**STAFF RECOMMENDATION**

**1505 Forrest Avenue  
October 19, 2016**

**Application:** Demolition—Outbuilding; New construction—detached accessory dwelling unit

**Description of Project:** Application is to demolish an existing outbuilding and construct a detached accessory dwelling unit (DADU) at the rear of the lot.

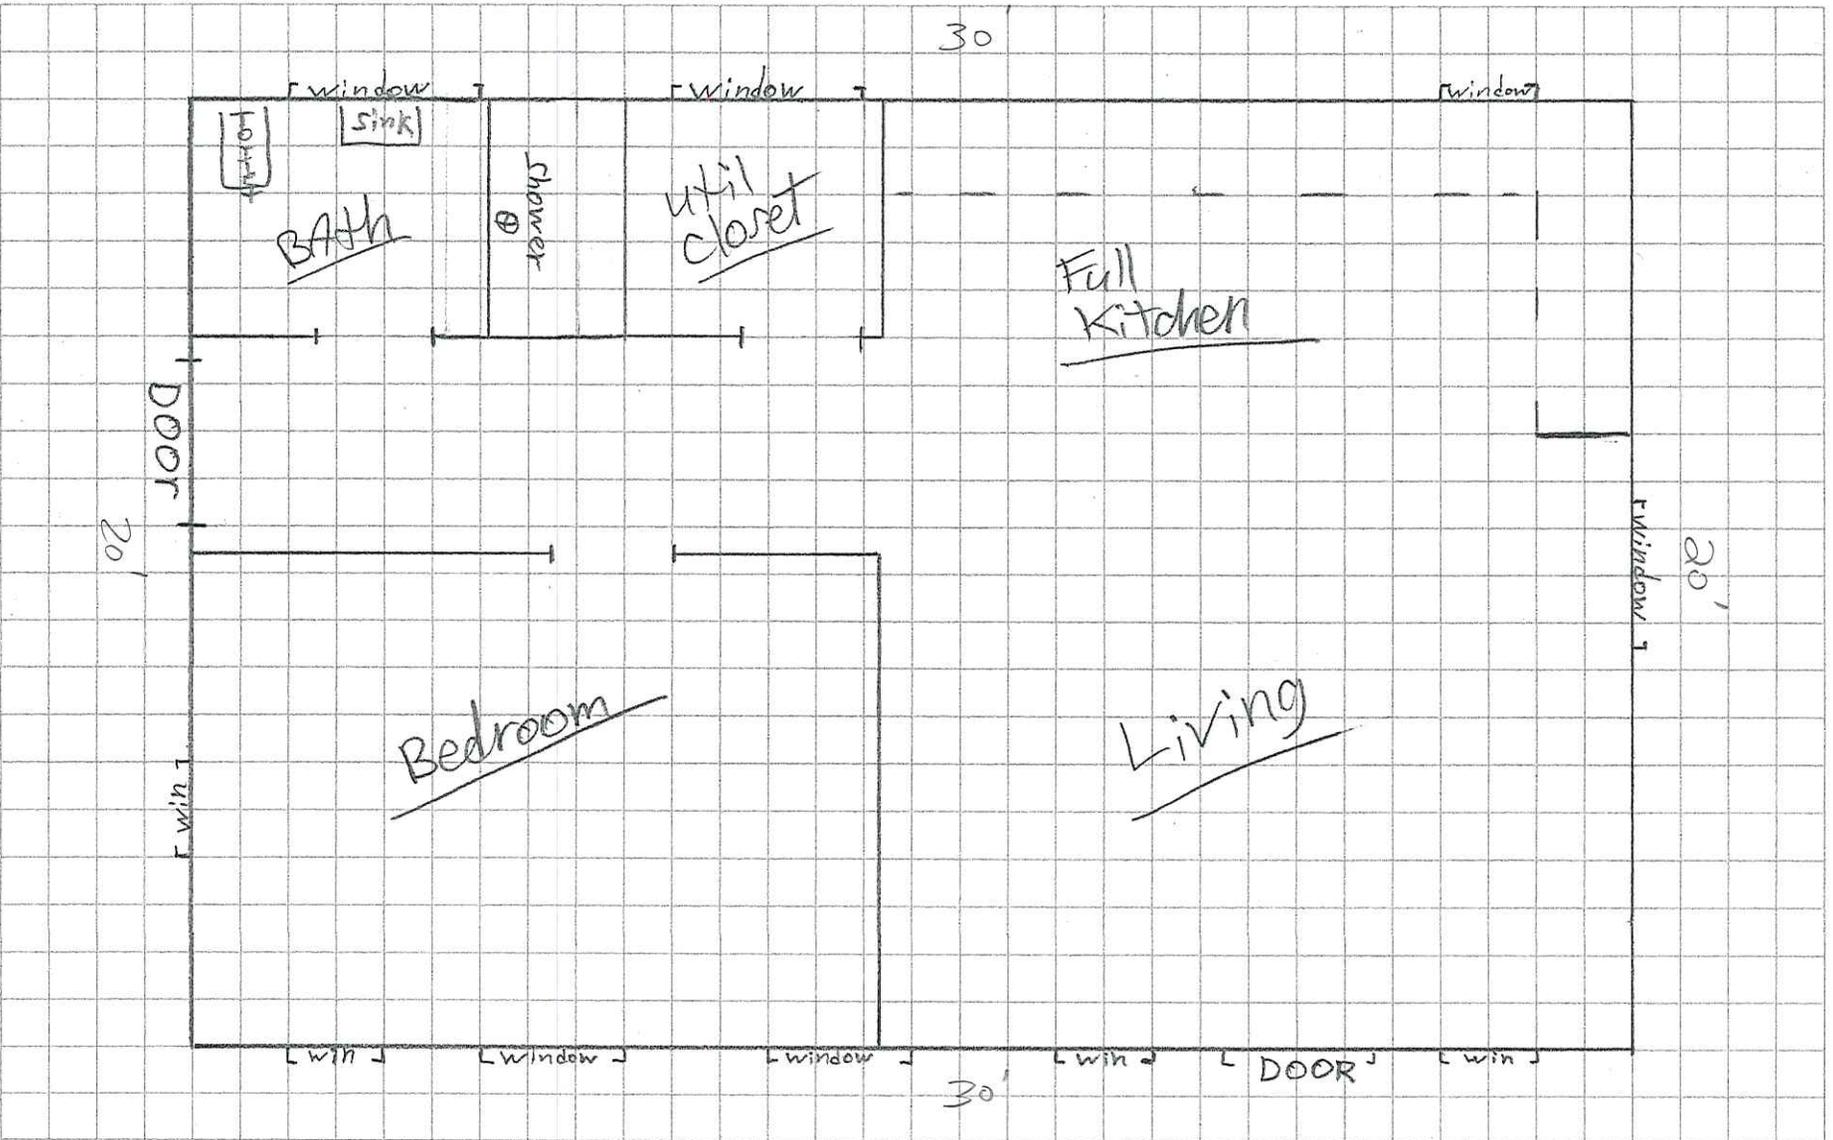
Setbacks: The proposed DADU meets all base zoning setbacks. It will be twelve feet (12') from the rear property line, three feet (3') from the left side property line, and twenty-seven feet (27') from the right side property line. Staff finds that the DADU meets Section II.B.3. of the design guidelines and 17.16.030.G. 4 of the ordinance.

<b>MINIMUM</b>	<b>PROPOSED</b>
<b>Space between principal building and DADU/Garage</b>	20'	20'
<b>Rear setback</b>	3'	12'
<b>L side setback**</b>	3'	3'
<b>R side setback**</b>	3'	27'
<b>How is the building accessed?</b>	From the alley or existing curb cut	N/A – no garage doors

**B:** Elevations

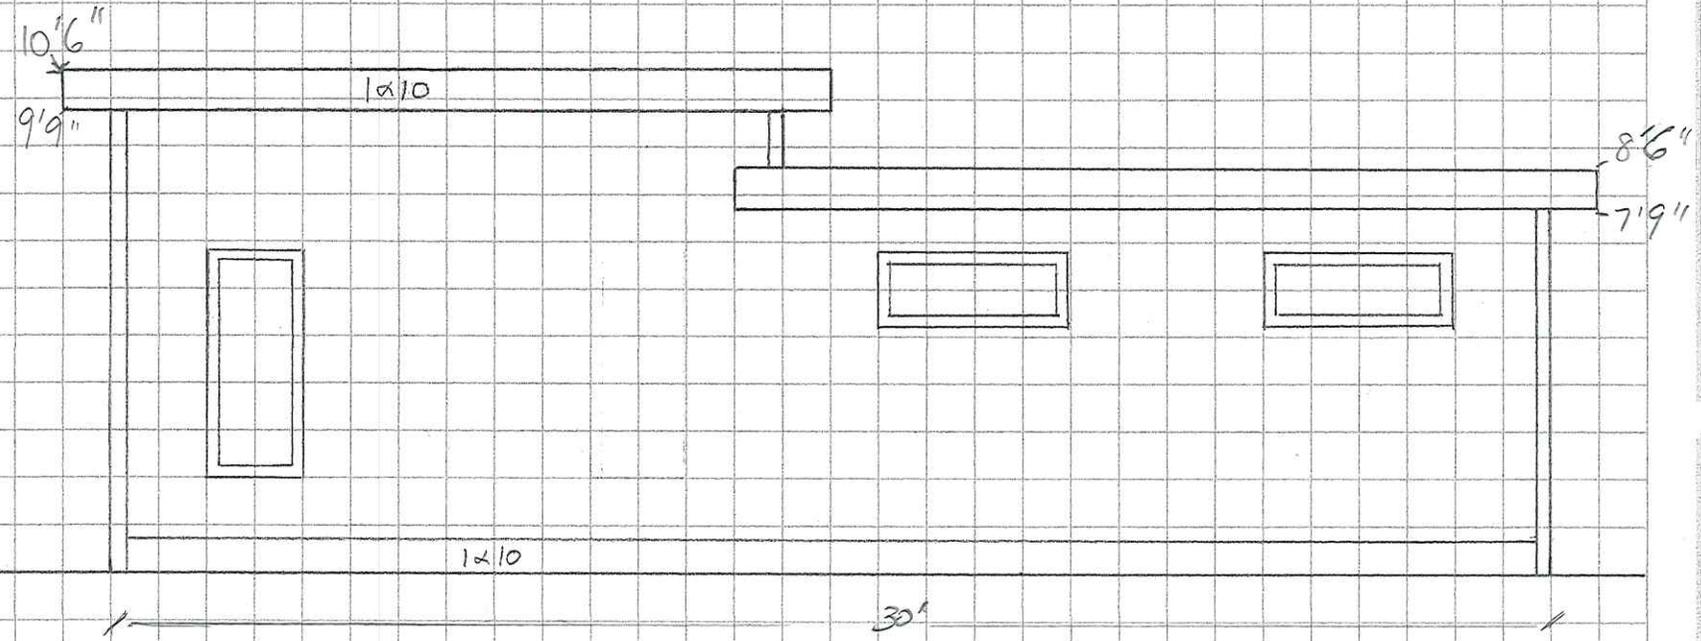
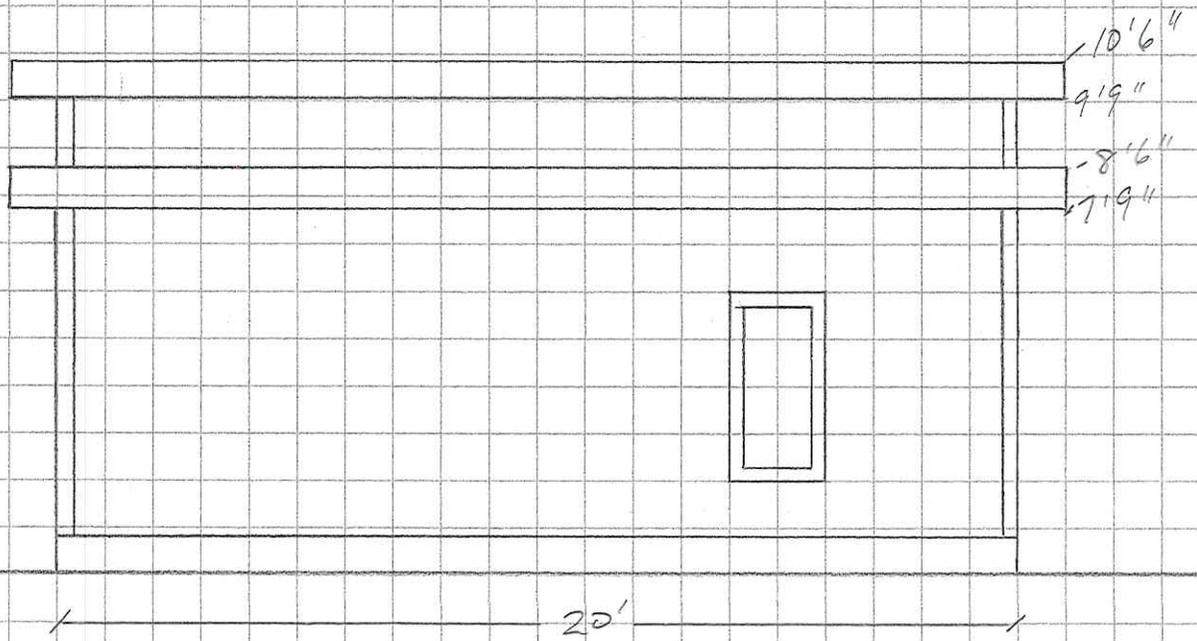
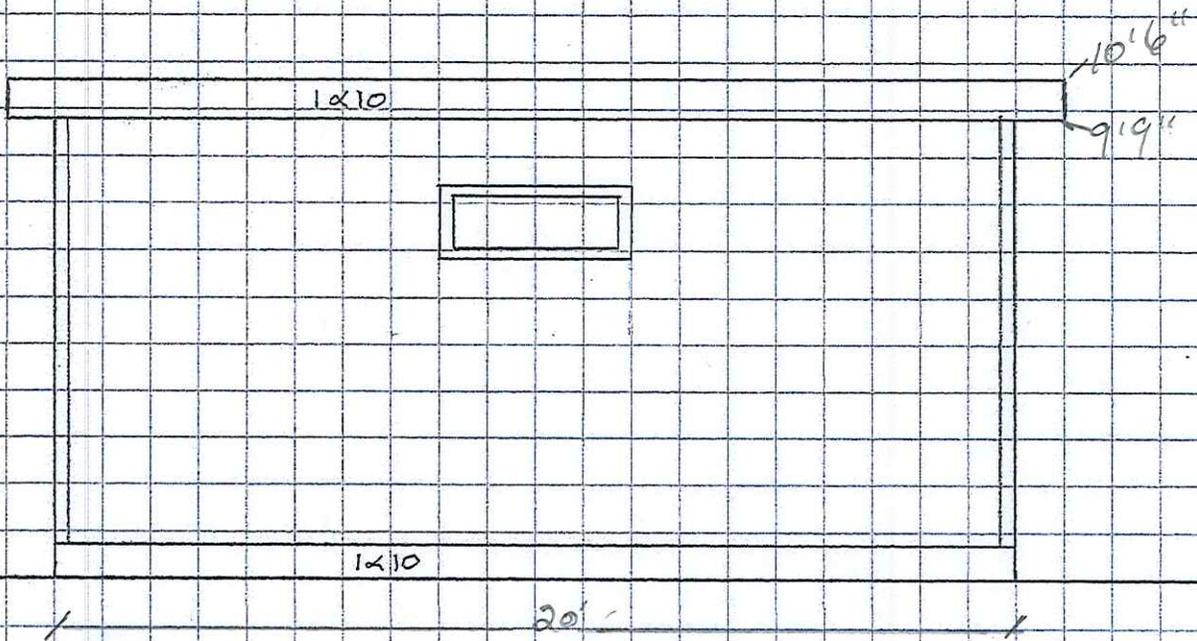
The applicant is proposing a one-story outbuilding that will be used as a detached accessory dwelling unit (DADU). A flat roof like the one proposed for the DADU is not typical of the neighborhood for historic primary structures. However, staff finds it to be appropriate for an outbuilding at the rear of the lot. Outbuildings were traditionally utilitarian in design. In addition, flat roof form allows the height of the structure to remain minimal and to be a true one-story structure. Staff finds that the DADU meets Section II.B.8 of the design guidelines and section 17.16.030.G.8 of the DADU ordinance.

Design Standards: The accessory structure has a simple, utilitarian design that is appropriate for outbuildings. Its roof form, detailing, and form do not contrast greatly with the primary structure. The fenestration is of a more modern layout and is atypical of the neighborhood context, but is appropriate for an outbuilding. It is also in a minimally-visible location at the rear of the historic house. Staff finds that the DADU's design meets section II.B.8 of the design guidelines and Section 17.16.030.G.8 of the ordinance.

<b>Proposed</b>	<b>Color/Texture</b>	<b>Approved Previously or Typical of Neighborhood</b>
<b>Foundation</b>	Concrete slab	Natural color	Yes
<b>Cladding</b>	Cement-fiber	Smooth with 4" reveal	Yes
<b>Roofing</b>	Rubber membrane	Unknown	Yes
<b>Trim</b>	Cement fiber	smooth	Yes
<b>Windows</b>	Marvin Integrity	Fiberglass	Yes
<b>Pedestrian Door</b>	Not indicated	Needs final approval	Unknown

<b>Existing conditions (height of historic portion of the home to be measured from finished floor)</b>	<b>Potential maximums (heights to be measured from grade)</b>	<b>Proposed (should be the same or less than the lesser number to the right)</b>
<b>Ridge Height</b>	19'	25'	10'6"
<b>Eave Height</b>	10'	1 story 10' or 2 story 17'	9'9"

1. Staff approve the final details, dimensions and materials of the pedestrian doors prior to purchase and installation; and
2. Staff receive a copy of the filed restrictive covenant for the detached accessory dwelling unit prior to issuance of a permit.
